Project Name: **CIVIL WORK RELATED TO TAFT STREET FORCE MAIN
WALL LOSS VERIFICATION**

Solicitation No: **F-4706-22-OT**
Thursday, February 03rd, 2022 at 3:00pm

CIVIL WORK RELATED TO TAFT STREET FORCE MAIN WALL LOSS VERIFICATION Addendum 1

Project Number: 20-7105A

Exhibit 2

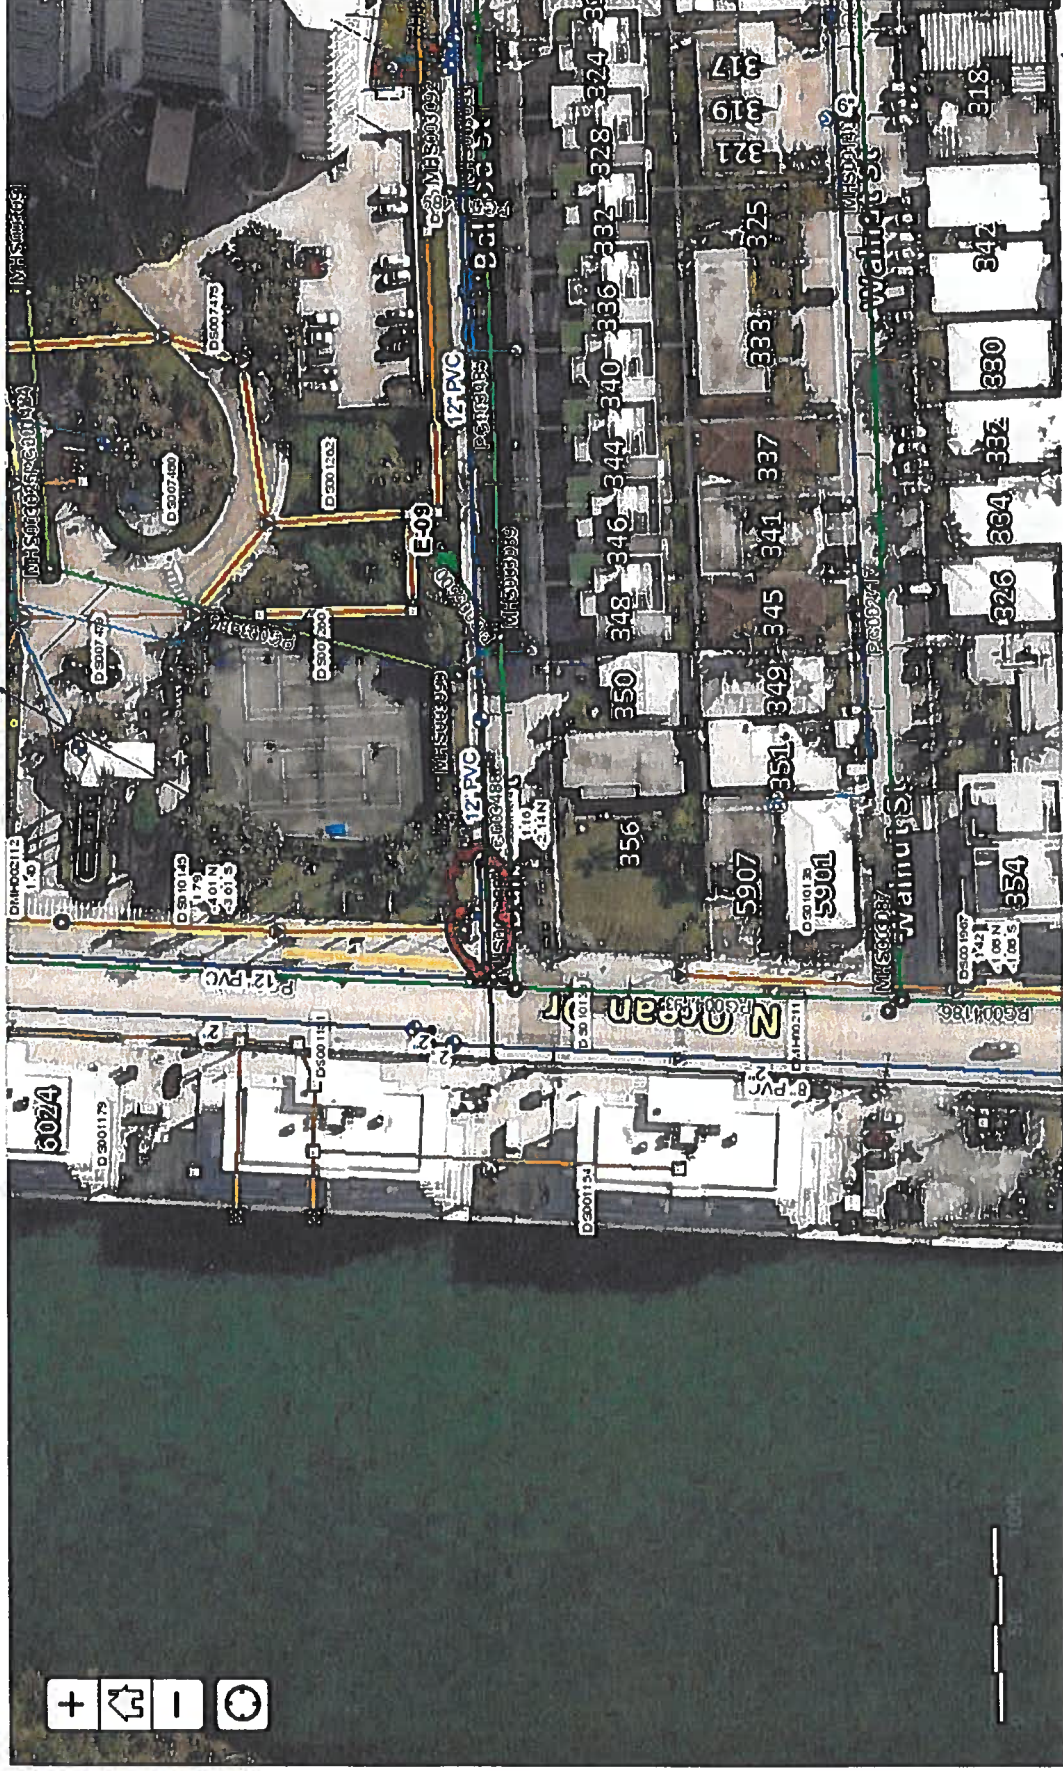
Please refer to attached Exhibit 2 for repair of 12" diameter PVC water main at intersection of A1A and Balboa Street. Contractor needs to submit required MOT for approval by FDOT and set up MOT, arrange utility locations in the area, remove asphalt pavement, install sheeting piles and dewatering well points if required, excavate, replace the 12" water main as needed using DR 18 PVC pipe and hymax couplings, backfill, arranging density test, final pavement per FDOT standard, traffic marking, traffic stripe and other site restoration. The CITY reserves the right to award any, all, or none of the money associated with this item.

Replace leaking 12" water main

Repair Leaking 12" Water Main at Intersection of MA & Balboa Street

Exhibit 3

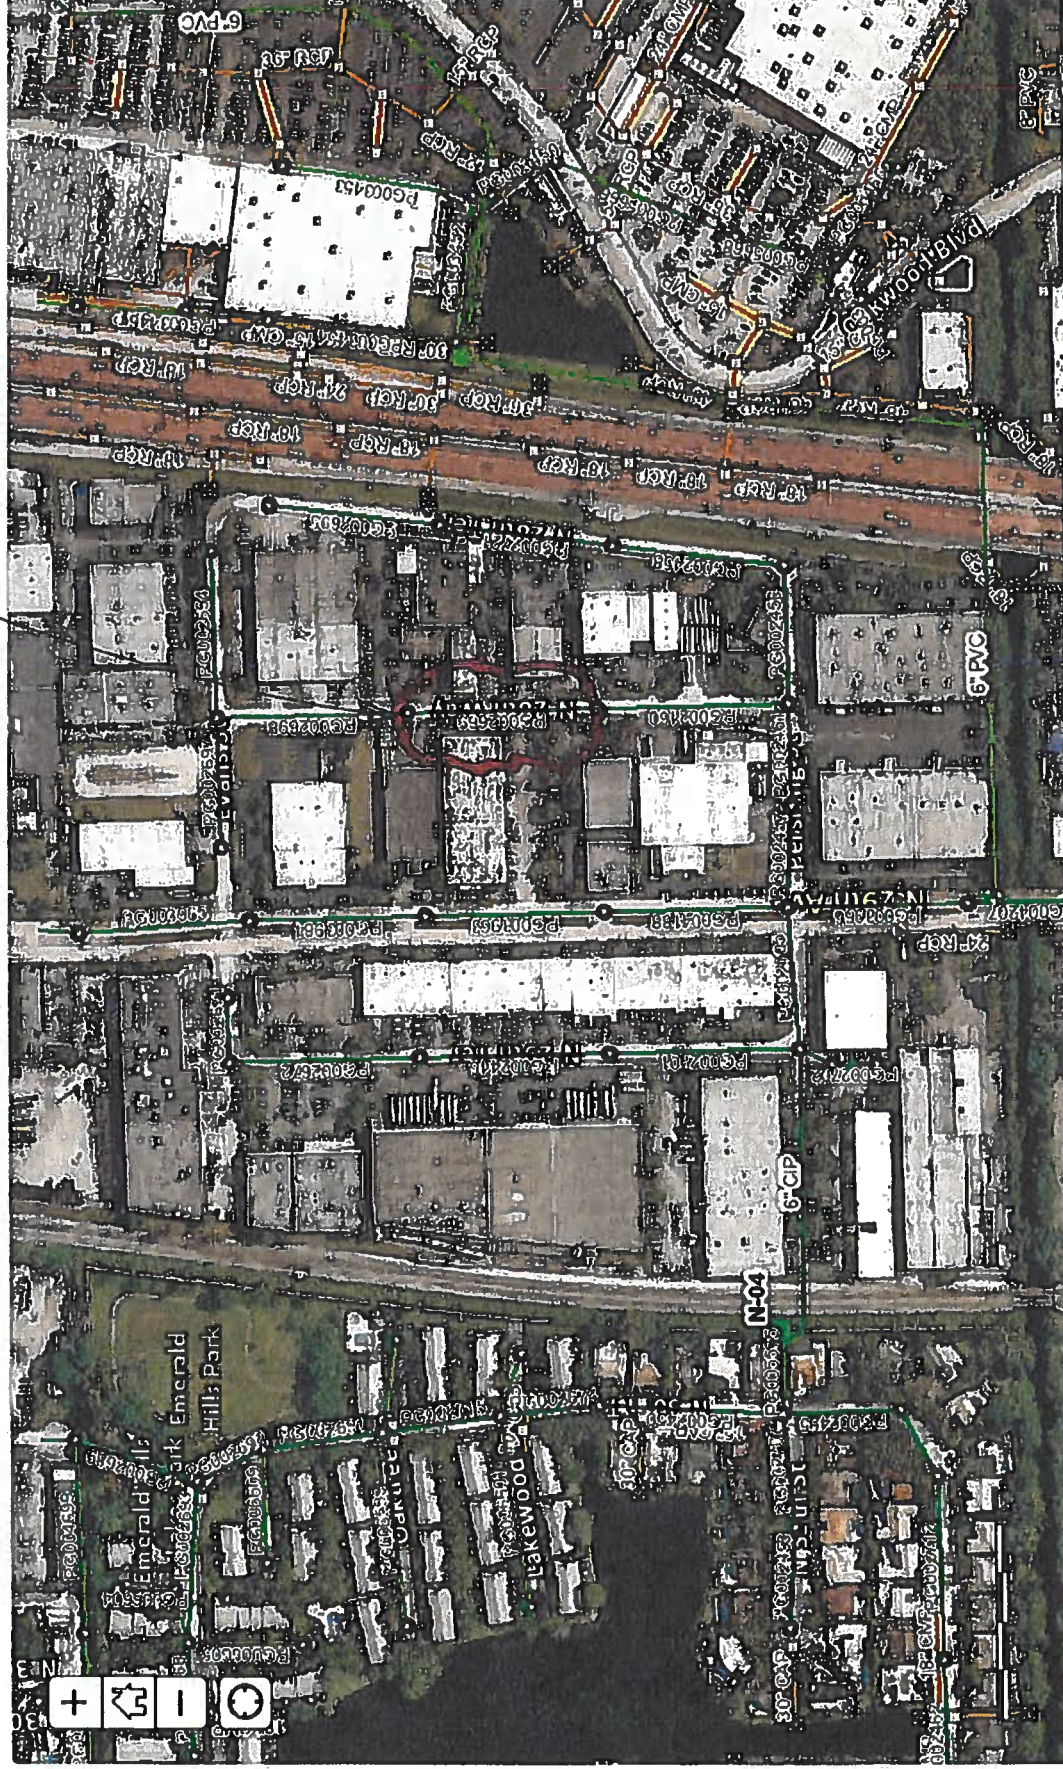
Please refer to attached Exhibit 3 for replacement of 8" diameter sewer gravity main along N 28th Ave between Evans Street and Pershing Street. Contractor needs to submit required MOT for approval by City of Hollywood Development and set up MOT, arrange utility locations in the area, remove asphalt pavement, install sheeting piles if required, excavate, replace the 8" diameter sewer gravity main using DR 18 PVC pipe and molded PVC fittings, reconnect up to 5 PVC laterals, backfill, arranging density test, sewer gravity pipe slope test, final pavement per FDOT standard, traffic marking, traffic stripe and other site restoration. The CITY reserves the right to award any, all, or none of the money associated with this item.

Replace ~392 LF 8" Gravidy
Sewer Pipe, 6' to 8' deep

Replacement of 8" Gravidy Sewer Pipe along H 28th Ave
